# 6811B-03 <u>SERVICE NOTE</u>

# 6811B AC Source/Analyzer

Serial Numbers: US38390001- US38399999, MY41000101- MY41001051, SG41000101-SG41000175

#### Page 3 of 6 Figure 1. A7 Inverter PCA Top View

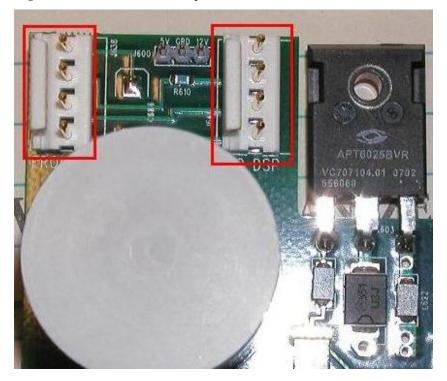
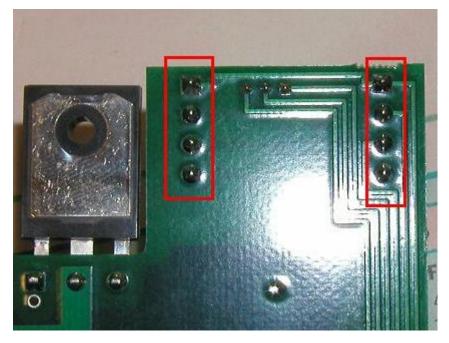
The first two connector headers are J638 and J646 on the A7 Inverter PCA. They need to be changed to the four pin connector, part number 1253-7410. These connectors should be fairly easy to desolder.

### Page 4 of 6 Figure 3. A7 Inverter PCA Top View

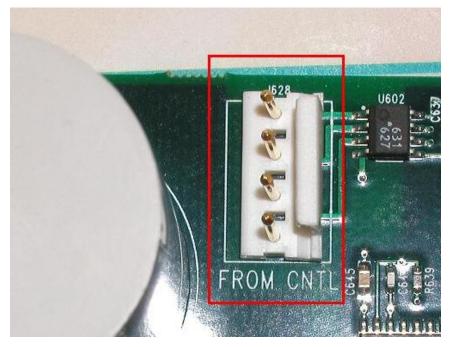
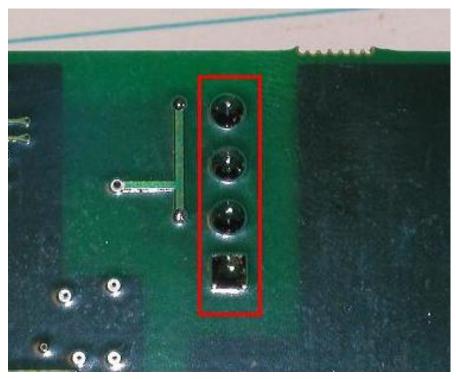
J628 on the A7 Inverter PCA also needs to be changed with part number 1253-7410. This should also be easy to de-solder.

Figure 6. A8 DSP PCA Bottom View

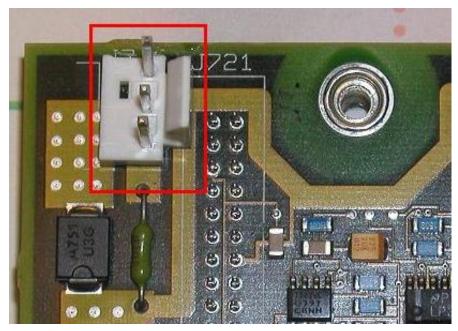
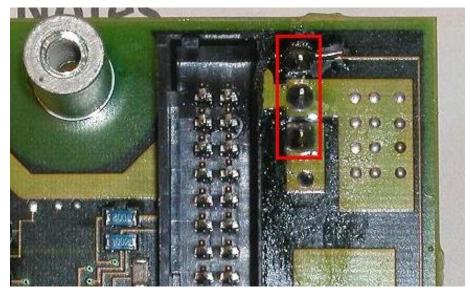
J721 on the A8 DSP assembly must also be changed. This is a three pin connector and should be changed to part number 1253-7460. This connector is hard to de-solder due to it being on top of a ground plane so extra care must be taken in order to avoid damaging the PCA. It is recommended to use solder wick instead of a de-soldering station.
